Your Ref: 20/00315/OUT

Proposal: Outline application for the erection of up to 245 dwellings with public open space, structural planting and landscaping, surface water flood mitigation and attenuation and vehicular access point from Hempsted Lane. All matters reserved except for means of vehicular access.

4.0 Comments on Development Framework Plan **(Wardell Armstrong GM10710-012 Rev H 20/01/2019)**

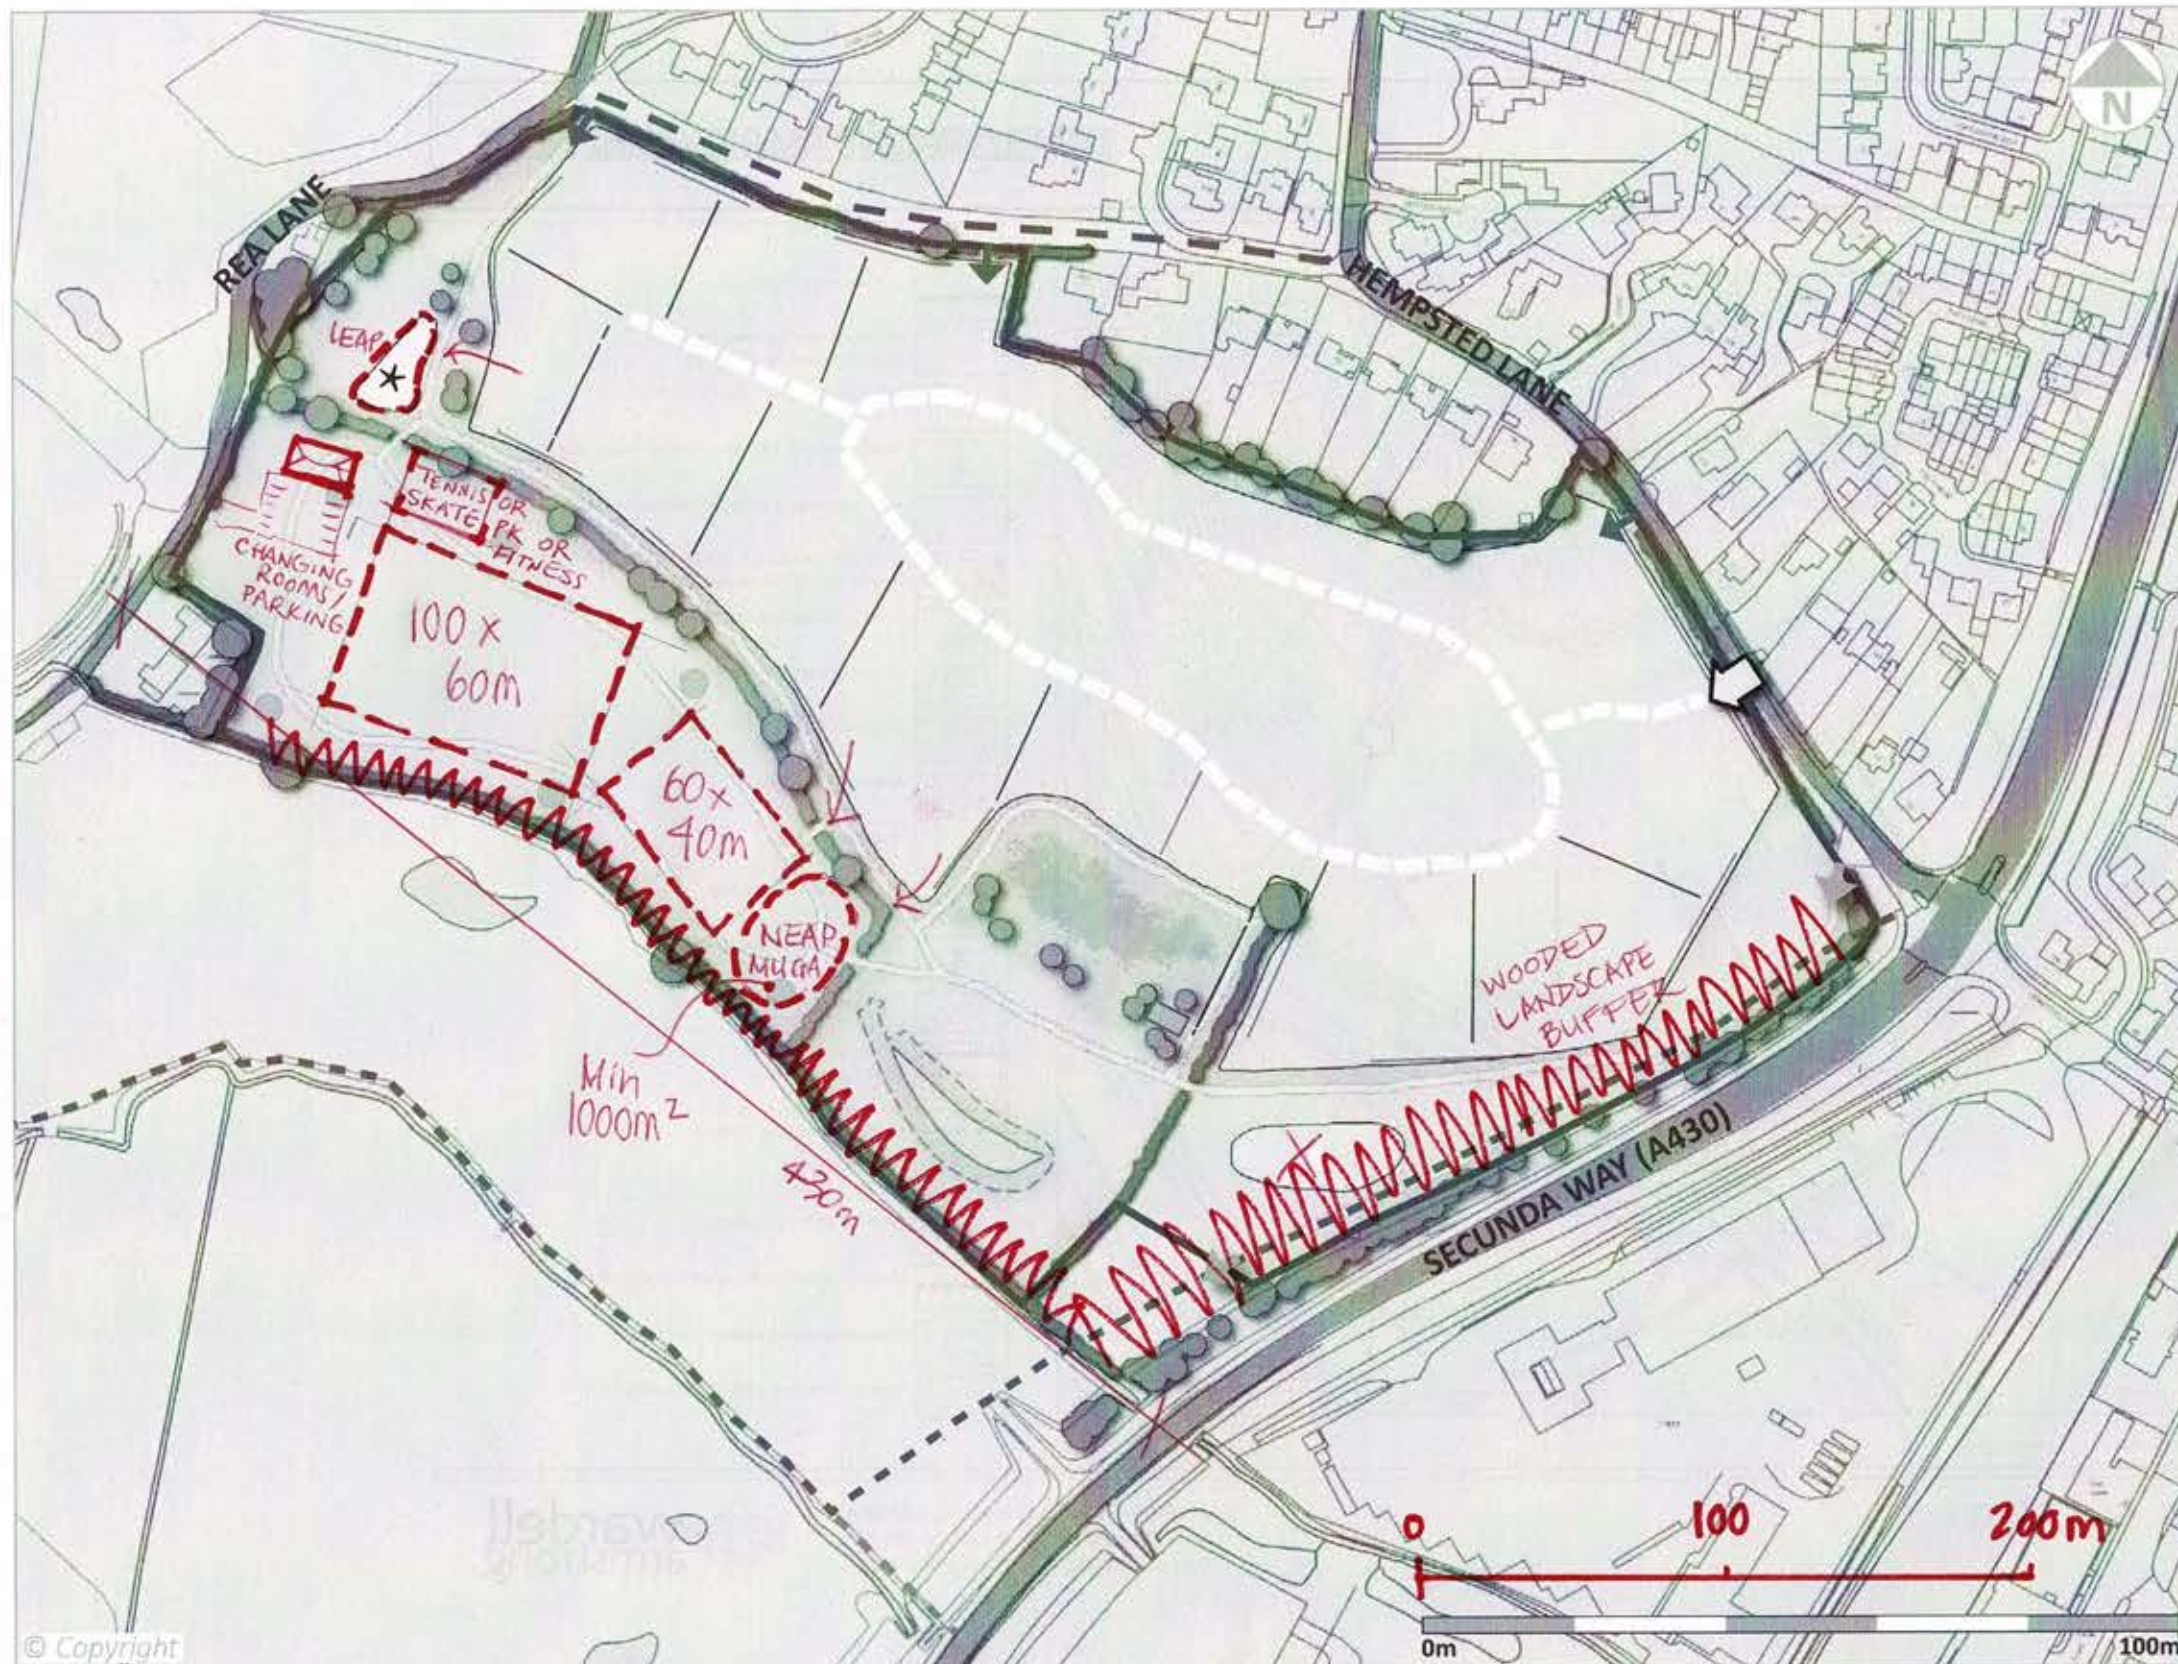
The indicated position of the NEAP, close to the Hempsted Bypass, is not acceptable and the NEAP (with associated MUGA) should be moved further towards the centre of the site's green space, away from the A430 traffic noise. A formal full-sized sports pitch (and mini pitch) could be accommodated on the western field (changing rooms would need to be positioned out of the flood zone). There should be some on-site parking provided for pitch users as well. I would be happy to provide more detailed comments, but they may not be necessary at this stage.

Please note: the linear scale bar on the Framework Plan is inaccurate. The site measures around 430m across at the bottom of the site – see marked up plan attached. The plan is to scale 1:2500@A3, but the linear scale on the plan is wrong. I have indicated how sports pitches could fit onto the site. If the development were to be given consideration I would like to see the eastern site boundary to the A430 have a deep wooded landscape buffer planted, to screen views across the site (and for ecological benefits too).
